Subject: Indian Point 3 Nuclear Power Plant
Docket No. 50-286
Control of Heavy Loads Review - General
Requirements for Overhead Handling Systems

CONTROL OF HEAVY LOADS

POWER AUTHORITY OF THE STATE OF NEW YORK
INDIAN POINT 3 NUCLEAR POWER PLANT
DOCKET NO. 50-286
JUNE 22, 1981

RESPONSES TO REQUESTS
FOR
INFORMATION IN SECTION 2.1
OF ENCLOSURE 3 TO JULY 31, 1980
LETTER - EISENHUT TO BERRY

FIGURE 6
INTERNALS LIFTING RIG

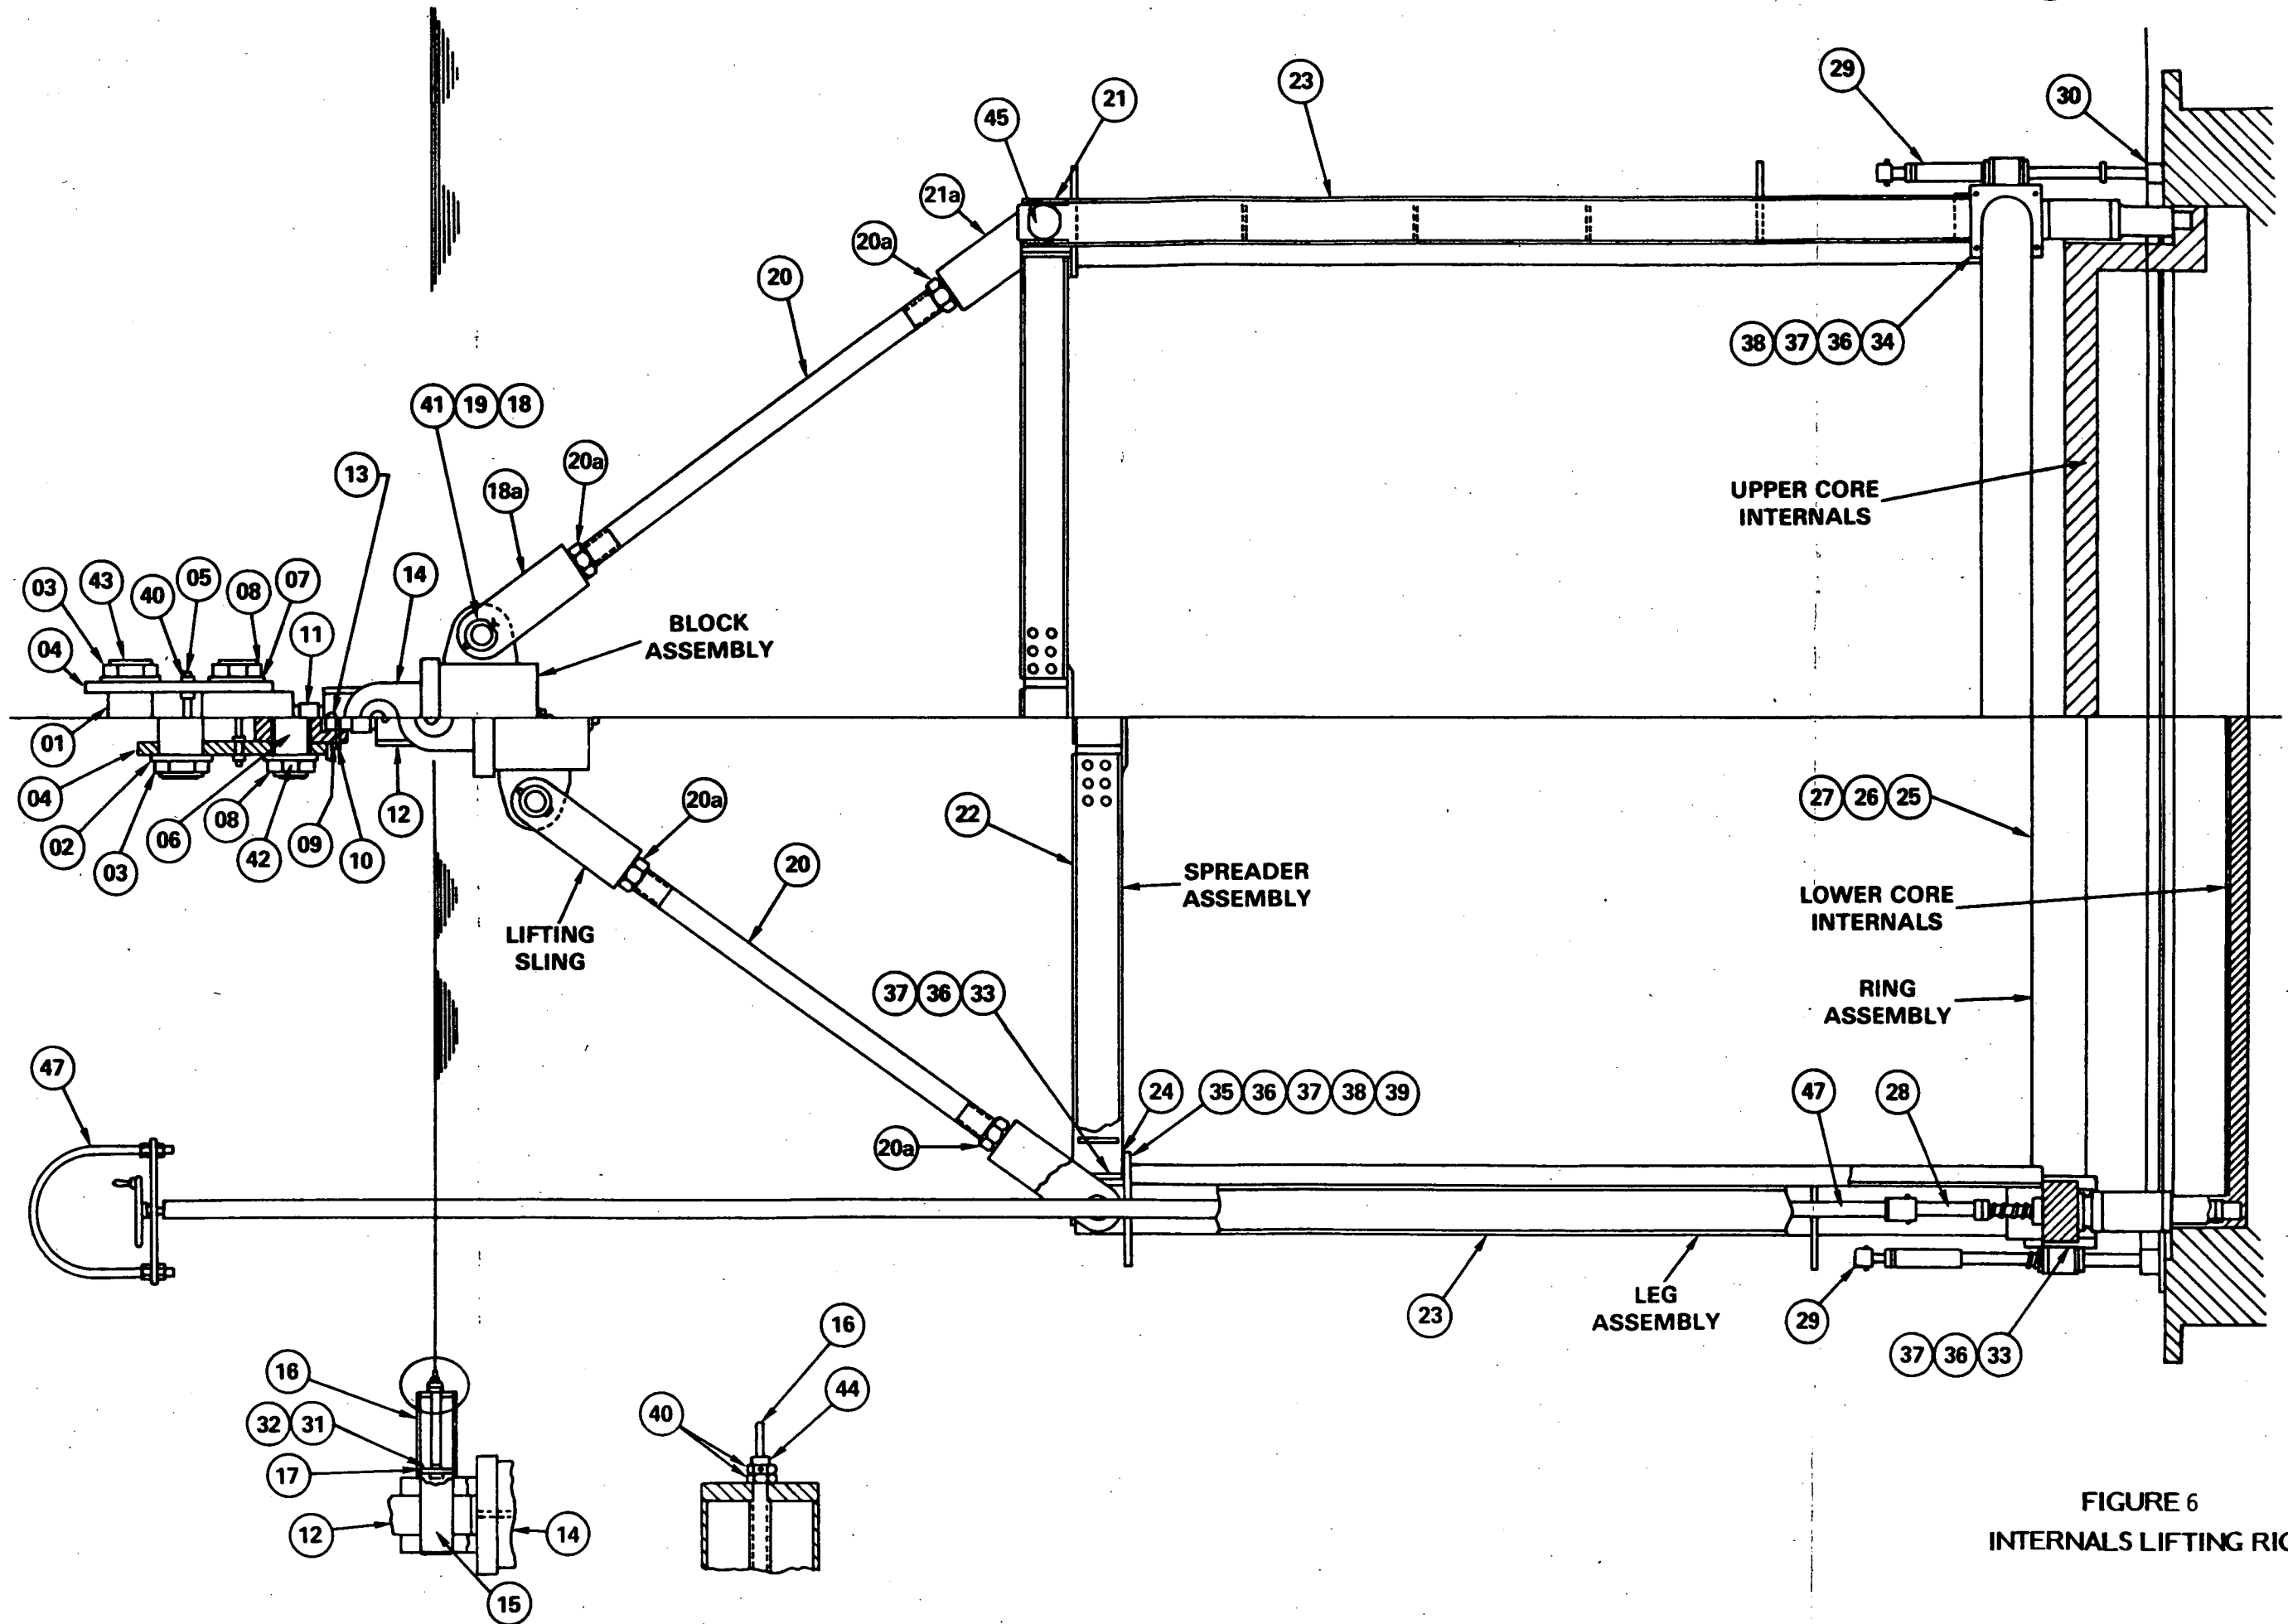
The Internals Lifting Rig (Figure 6) is a structural frame device, designed for removal and installation of the reactor upper and lower internals. The frame consists of a spreader assembly, three tubular columns and a support ring assembly. It is suspended from the main hook of the Polar crane with a sling assembly similar to that used for lifting the reactor vessel head. Located on the top portion of the rig is the spreader assembly, constructed of a series of I beams welded together in a y-shaped fashion. Grating placed on top of the fabricated member with removable handrails positioned on both sides of each walkway provides an operating platform for personnel. Three pad eyes are installed on

Exception 5: As to the Reactor Head Lifting Rig and the Internals Lifting Rig, there are several components whose inspection in accordance with all of the requirements of 5.3.1(2) on an annual frequency is impractical. These components are those that require disassembly not normally performed or removal of protective coatings. The proposed inspections of all load bearing components and critical areas including exceptions for these rigs are indicated in Tables 4 and 5. The component numbers refer to those on Figures 5 and 6.

TABLE 5 - Internals Lifting Equipment Inspection

NOTE: Examination of threaded portions of Item 20 that are not visible shall be conducted at a five year interval.
